STAFF RECOMMENDATION

912 Apex Street
February 18, 2015

Application: New construction – infill; Setback determination
District: Greenwood Neighborhood Conservation Zoning Overlay
Council District: 06
Map and Parcel Number: 08204027700
Applicant: Bob Potter, Kudzu Homes
Project Lead: Sean Alexander, sean.alexander@nashville.gov

Figure 1: Box # 1 shows the proposed double-wide parking area and box #2 shows the suggested driveway.

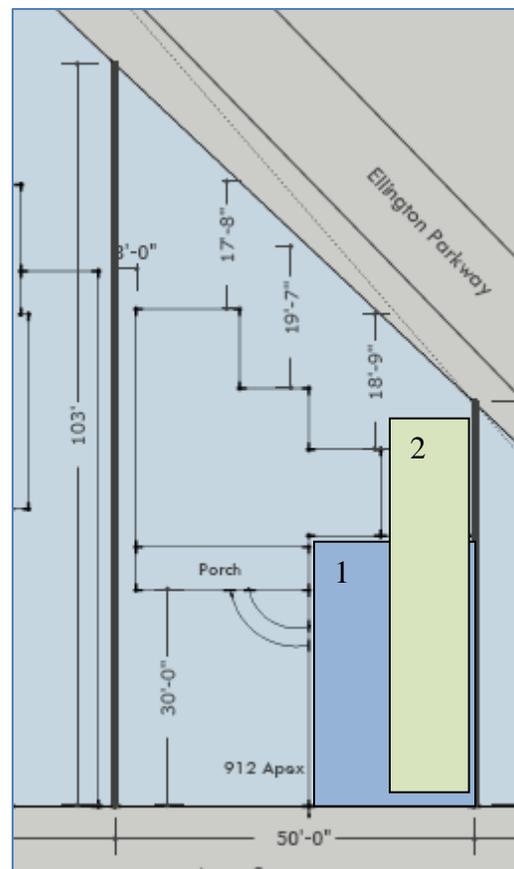
The house will face the street with a six foot (6') deep porch recessed underneath the primary roof. The site plan does not show a walkway from the front porch to the street, but does show a paved driveway in front of the house. Staff recommends that a walkway be added to

connect the house to the street. The applicant proposes a front yard, double-width parking area. There is approximately twelve and one-half feet (12') between the side of the house and the right side property line. Staff recommends a ten to twelve foot (10'-12') driveway that extends to the rear property line, rather than the front-yard parking. (See Figure 1.) There is no alley access. With those changes, Staff finds that the orientation of the proposed infill will be compatible with surrounding historic houses and will meet section II.B.1.f of the design guidelines.

- Staff verifies that the floor height is compatible with surrounding historic houses;
- That the driveway extend along the right side of the building to the midpoint, instead of having a front-yard parking area;
- The window and door selections are approved by Staff;
- The roof color and brick porch column bases are approved by Staff;
- The HVAC is located behind the structure or on the sides, beyond the mid-point of the structure.

Site Plan
Scale - 1" = 20'

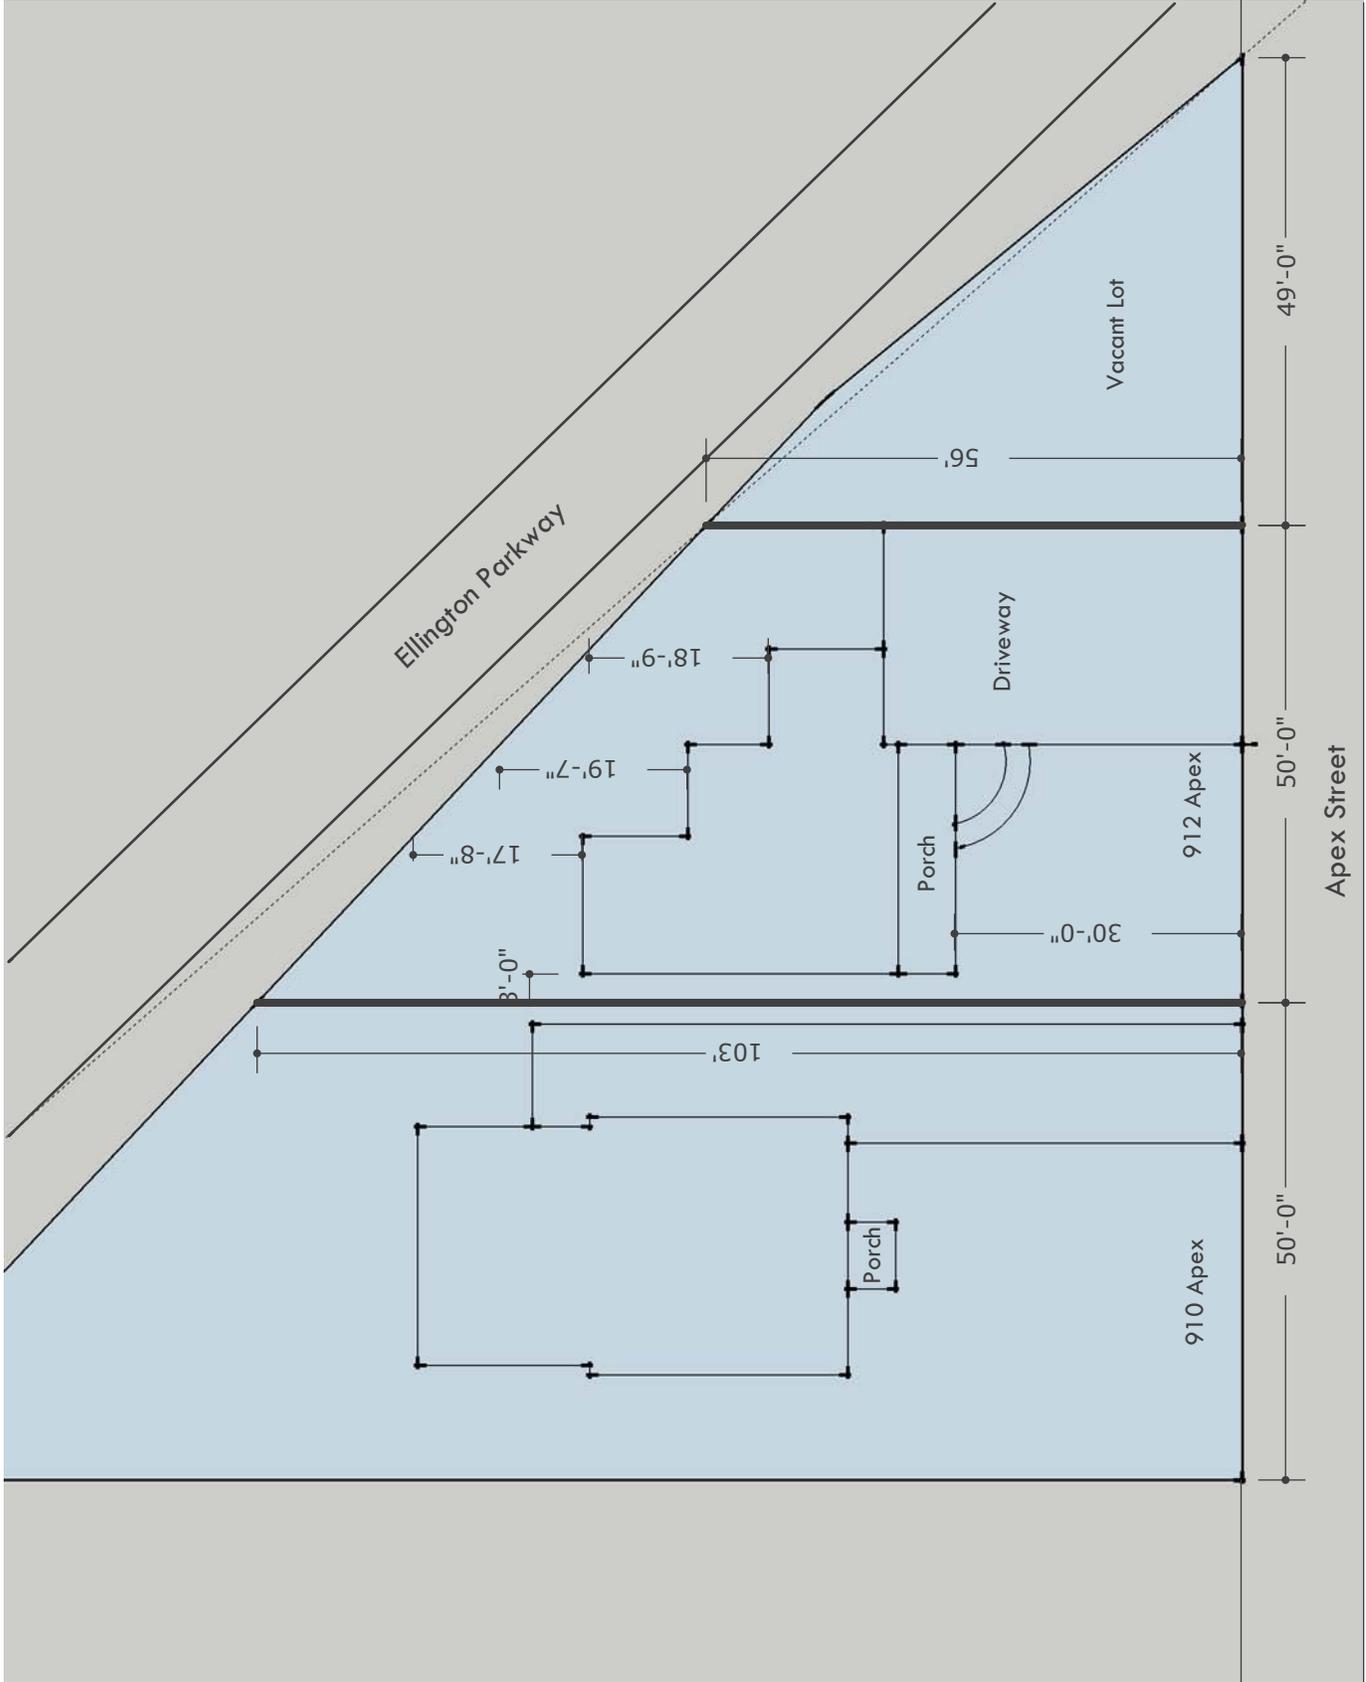
The location of the HVAC and other utilities was not indicated on the site plan. With a condition that the HVAC be located on the rear façade, or on a side façade beyond the midpoint of the structure, staff finds that the project meets section II.B.1.i of the design guidelines.
